HISTORIC AND DESIGN REVIEW COMMISSION

March 20, 2019

HDRC CASE NO: 2019-099

COMMON NAME: 115 S ZARZAMORA **ADDRESS:** 2607 BUENA VISTA ST

| Storefront (West) Elevation - Signs B

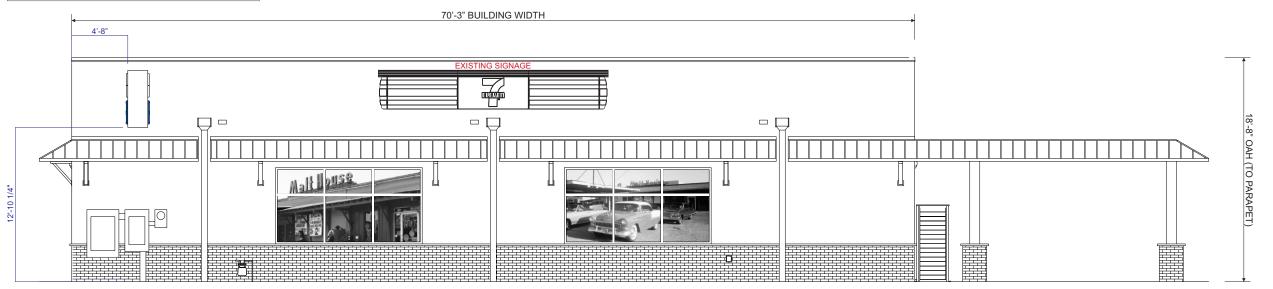
- e. WALL SIGN The applicant has proposed to install a new wall cabinet to be affixed above the western entrance of the structure. The sign will face towards the interior of the lot towards the parking lot and will not be visible from the public right-of-way. The signage will feature branding for a food vendor providing products within the gas station. Staff finds the proposal appropriate.

Item 2, Staff recommends approval of the proposed wall sign based on finding e.

| Rear (East) Elevation - Sign A

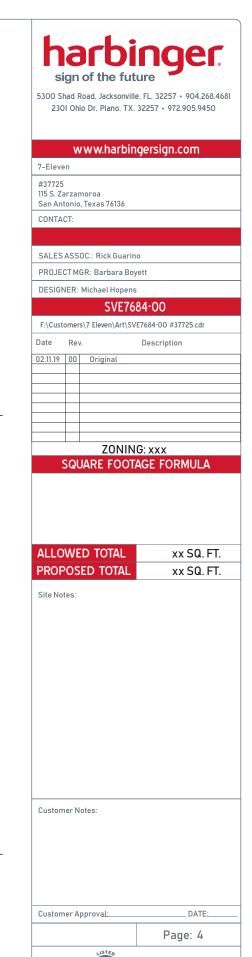
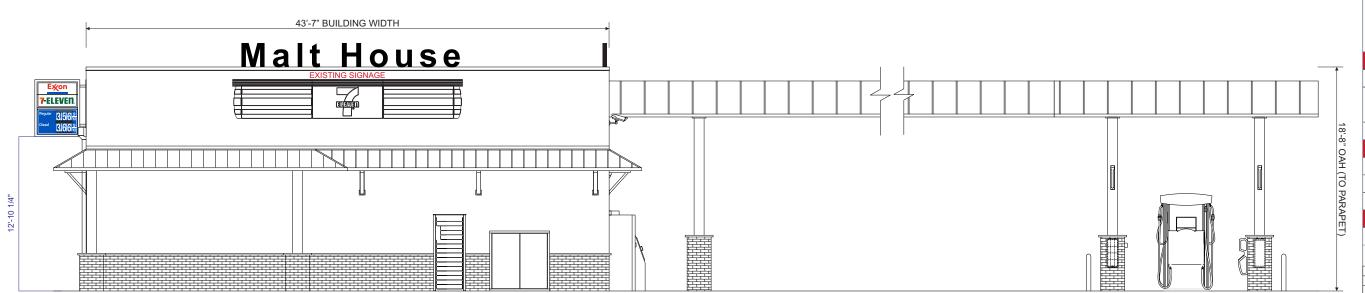
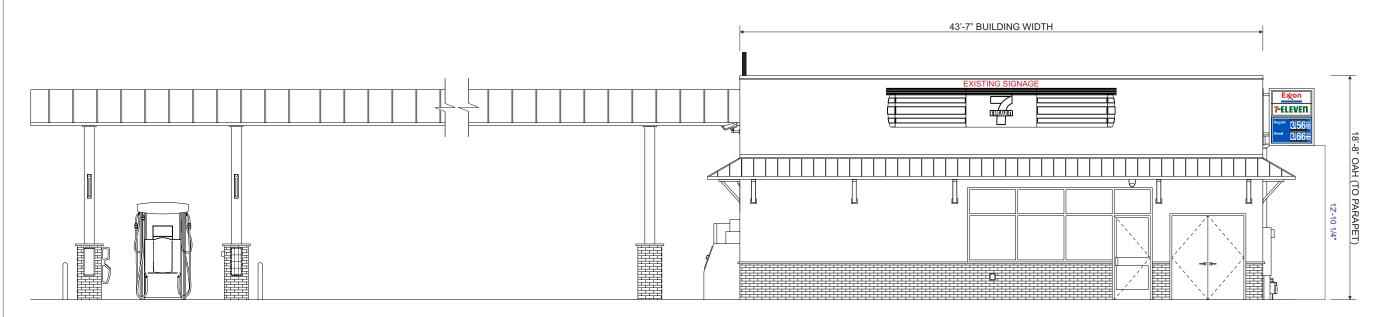
- d. RELOCATED MONUMENT SIGN The applicant has proposed to relocate a previously-approved LED internally illuminated monument sign to the side of the structure facing S Zarzamora. The sign will be modified to become a projecting blade sign and will be structurally affixed to the building. The cabinet is double-sided and features branding for Exxon and 7-Eleven, as well as rotating gas prices. The sign is double-sided and features approximately 35.6 square feet in total. The applicant is requesting this modification due to low visibility of the current sign location from the public right-of-way. According to the Historic Design Guidelines, projecting signs should be scaled appropriately, located on portions of buildings that commonly feature this type of signage, and be affixed in proper locations. It is not common to for signs of this proportion with gas price information to be affixed to a structure in the vicinity. Staff does not find the location of this sign appropriate.

Item 1, Staff does not recommend approval of the relocated monument sign based on finding d. The relocation of the monument sign to an alternate ground-mounted location on site is eligible for administrative approval.
